RENESAS TECHNICAL UPDATE

| Product Category | MPU & MCU | Document No. | TN-16C-A228A/E | Rev. | 1.00 |
| Title | Errata to M16C/5M Group, M16C/5L Group, M16C/5LD Group User's Manuals Regarding CAN Module | | Information Category | Technical Notification | |

Figure 25.34 Transition between CAN Operating Modes (i = 0, 1)

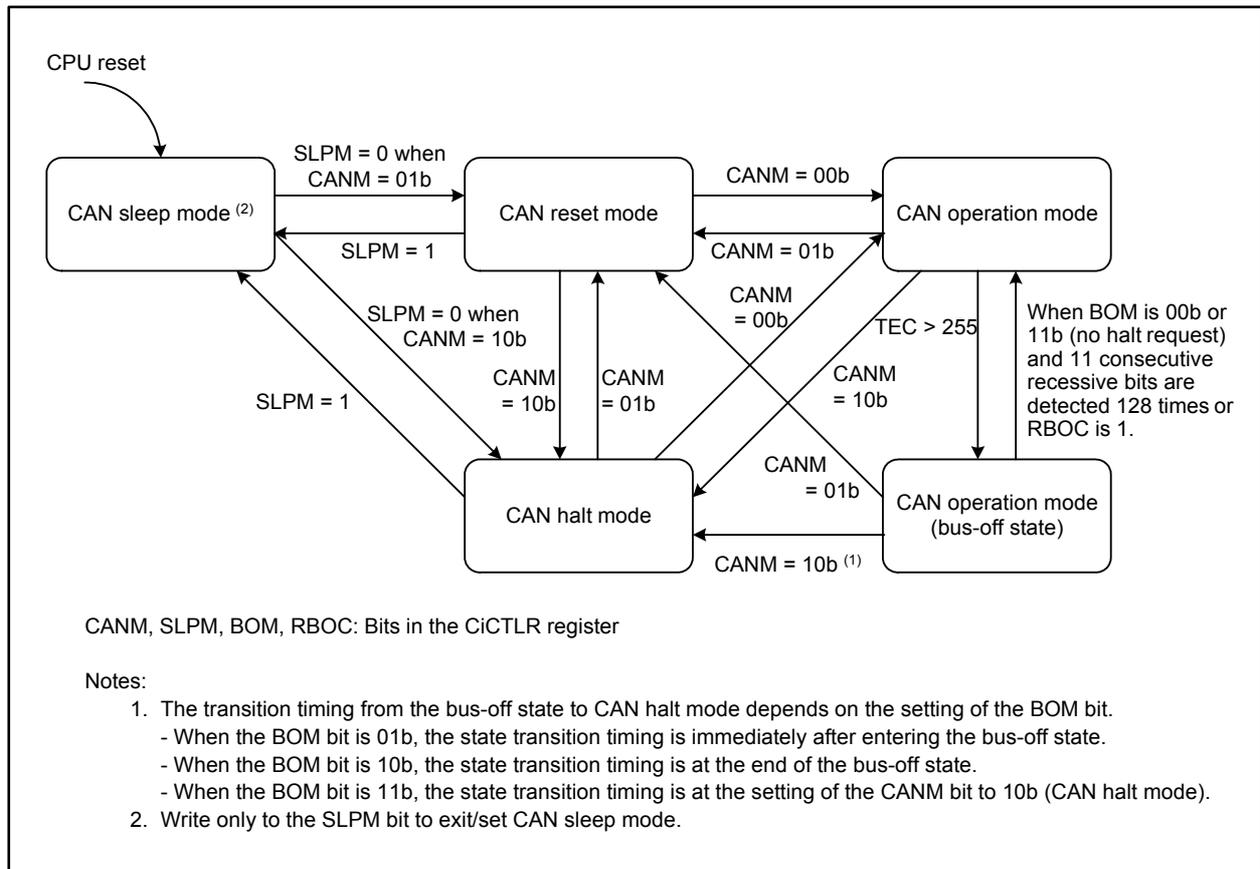
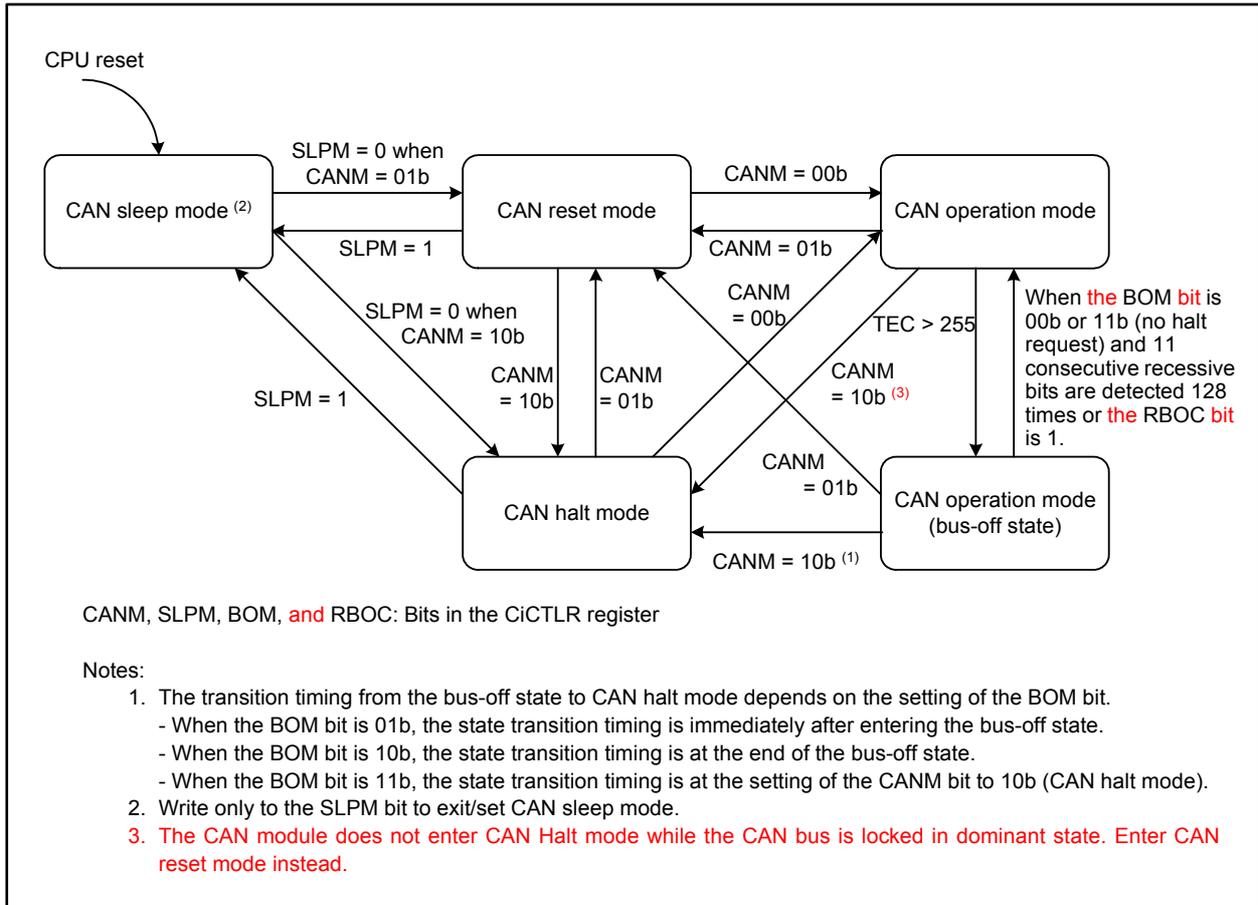
Note 3 is added to Figure 25.34 as follows:
